Metropolitan Planning Commission

Staff Reports

February 14, 2008

Myrtlewood Section Eight

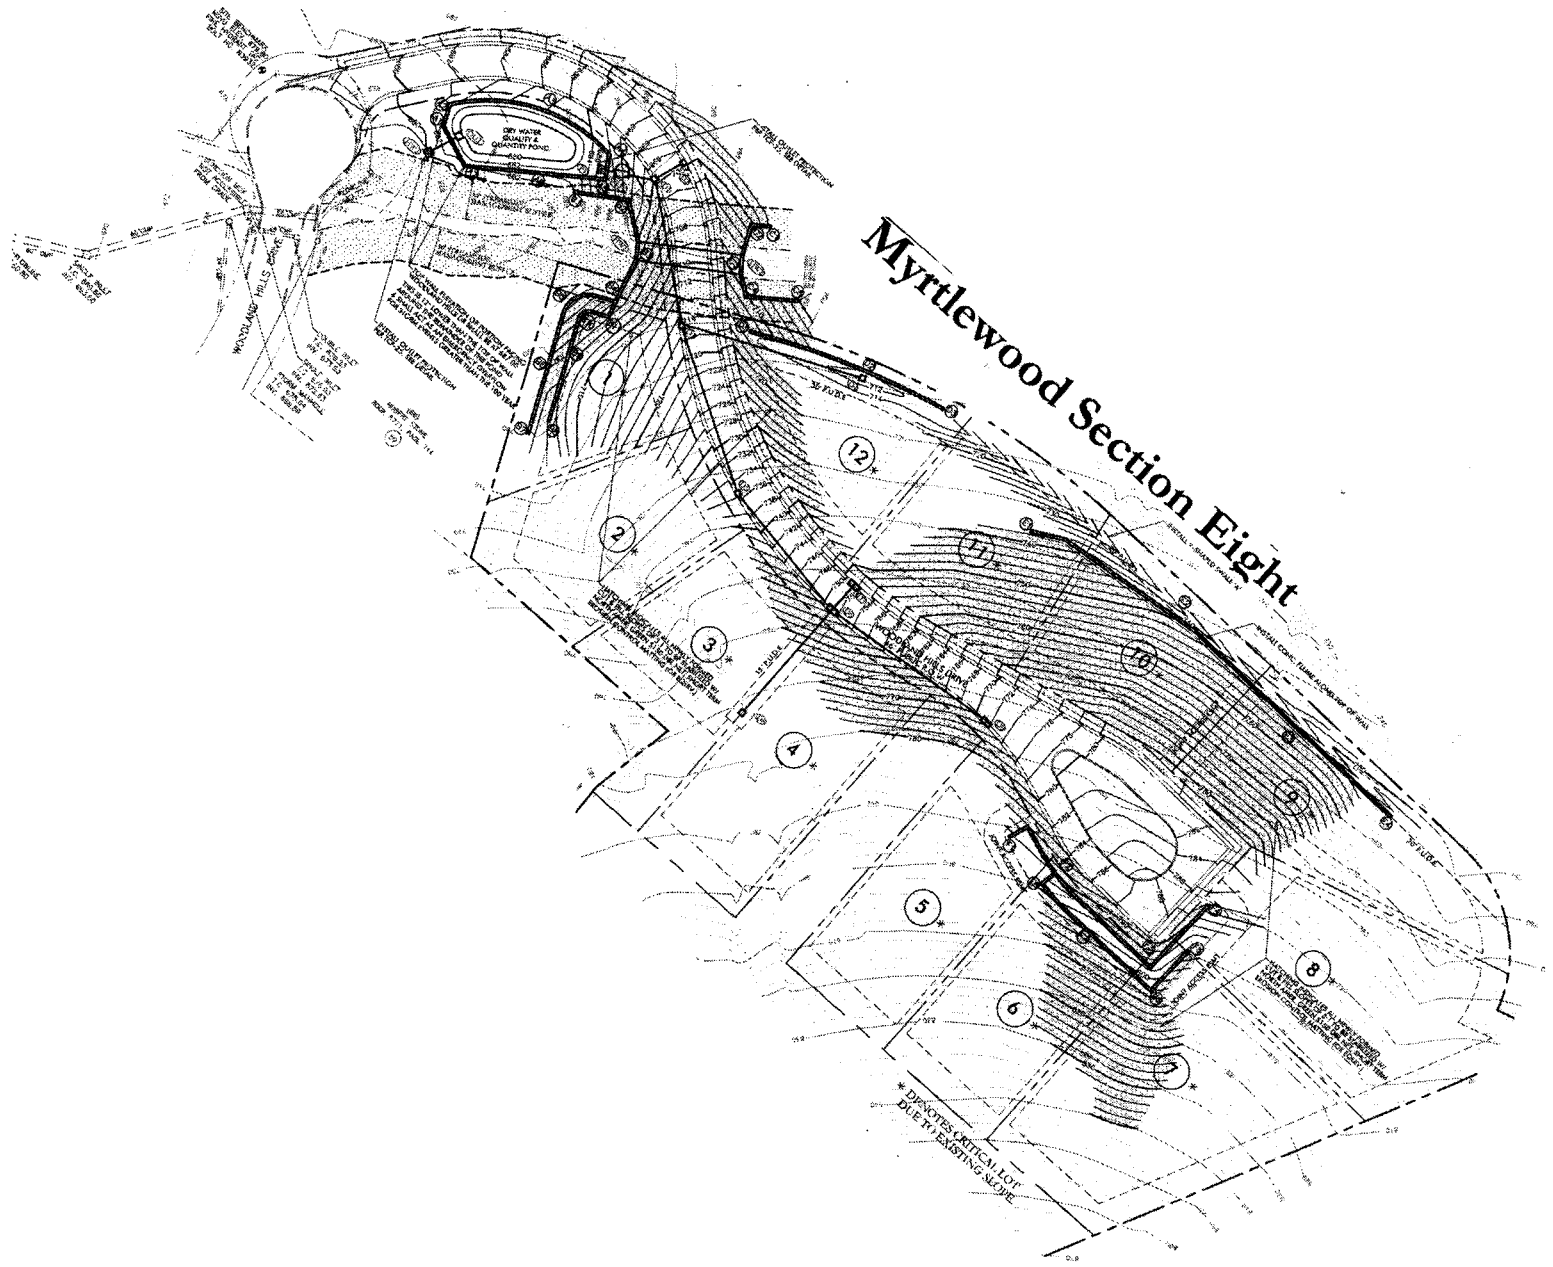
The revised preliminary plan proposes 12 single-family lots on a cul-de-sac. All 12 lots are identified as critical lots due to existing steep slopes and must comply with the Hillside Development Standards of the Metro Zoning Code.

The front and rear setbacks are 20 feet and the side setbacks are 5 feet. The maximum building height remains three stories. The revised site plan includes a joint access easement running along the southern portion of Lots 5 through 8 and another joint access easement on the right side of Lot 10. The previous 3.16 acres of open space along the southwestern side of the PUD has been relocated to the west and northerly portions of the PUD.

Retaining walls are proposed along the perimeter of the water quality and quantity pond on the northwest side of Woodland Hills Drive. Retaining walls are proposed on the northerly portion of Lots 1, 5, 6, 7, 8, 9, 10, 11 and 12. A fence will be required along the retaining walls of lots 9, 10 and 11 due to steep slopes.

8. Provide pre- and post-development drainage area maps.
9. Provide ARAP permit from TDEC and Section 404 from USACE due to stream crossing.
10. Drainage area map to pond appears incorrect. Area below lower inlets not draining to pond. SW area near existing ditch and eastern area beyond new ditch not going to pond. Please revise.

11. Water quality unit should be placed in location that can be maintained, preferably upstream of the dry pond. "Seam" elevation of 575.14 ft shown in the water quality vault detail (detail 2 of 3) does not correspond with the inflow and outflow invert elevations (698.9 ft and 698.7 ft).

1. The owner's signature of parcel 113 shall be required on the final plat so that right of way can be dedicated.
2. Applicant shall submit access and utility easement documentation for the entrance drive and pond for Woodland Hills Drive.

3. Fencing is required along the retaining walls of lots 9, 10, and 11.
3. This approval does not include any signs. Signs in planned unit developments must be approved by the Metro Department of Codes Administration except in specific instances when the Metro Council directs the Metro Planning Commission to review such signs.

Blakemore Neighborhood Conservation Overlay

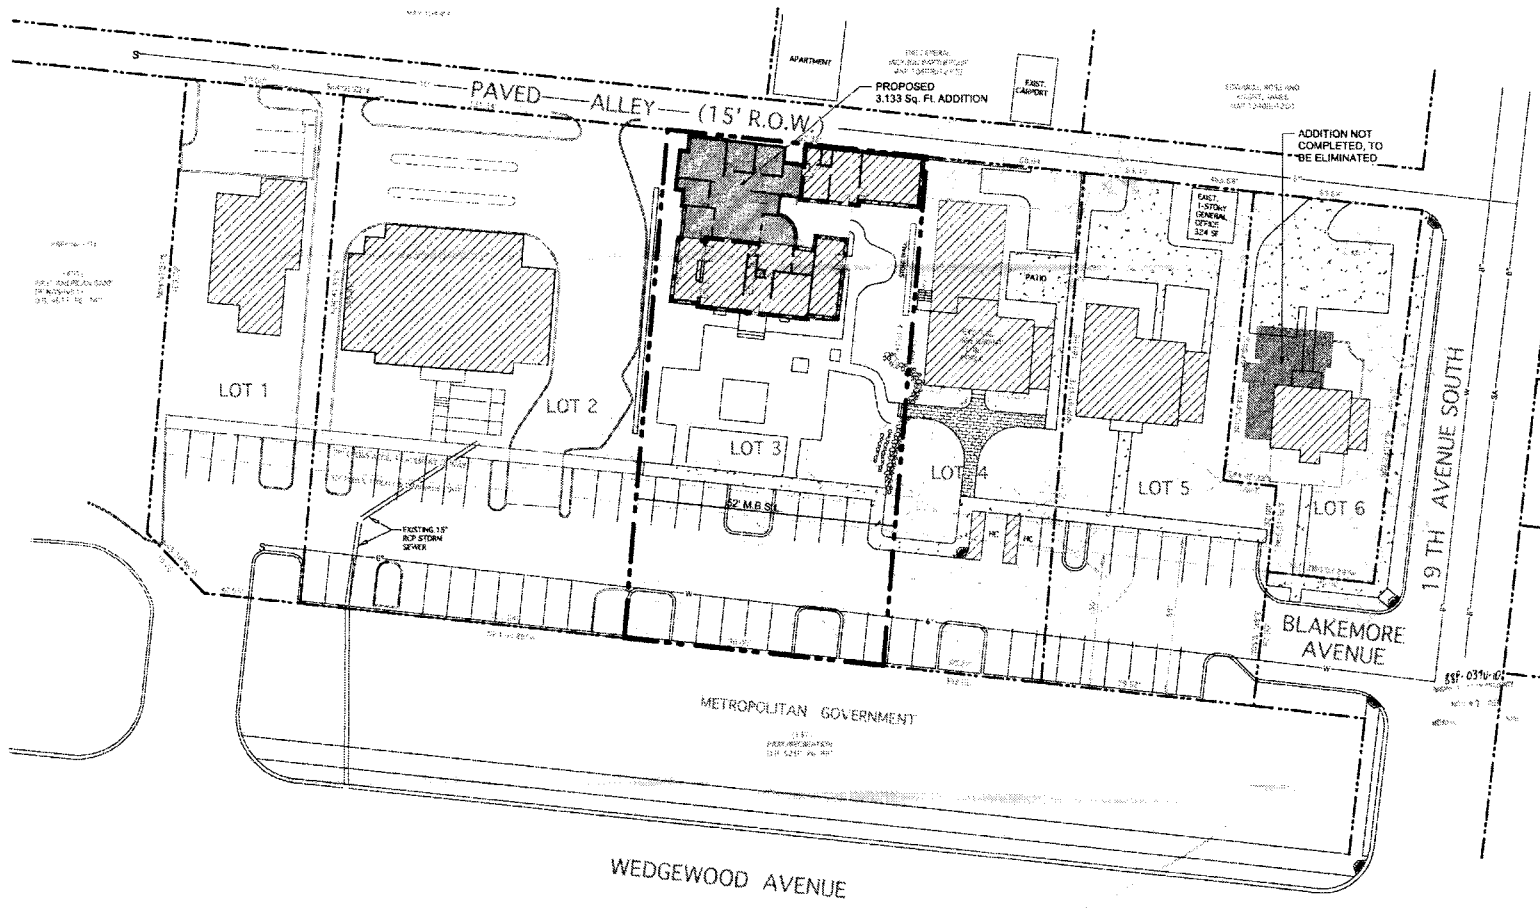
The revised plan calls for a 3,133 sq. ft. addition to the rear of an existing low-rise office building located on Lot 3 (1908 Blakemore Avenue). The addition will not be visible from Wedgewood Avenue. The plan also calls for the removal of development rights for a 1,300 sq. ft. addition which was previously approved for Lot 6 (1900 Wedgewood Avenue).

The proposed addition to the building will have a rear setback less than the minimum 20 feet required by the Zoning Code. While this does not meet the zoning

requirement, Council recently approved Ordinance No. BL2007-45 which gives the Historic Zoning Commission the ability to determine the appropriate setback for structures within historic overlay districts. The Historic Zoning Commission has approved the plan including the proposed setback.
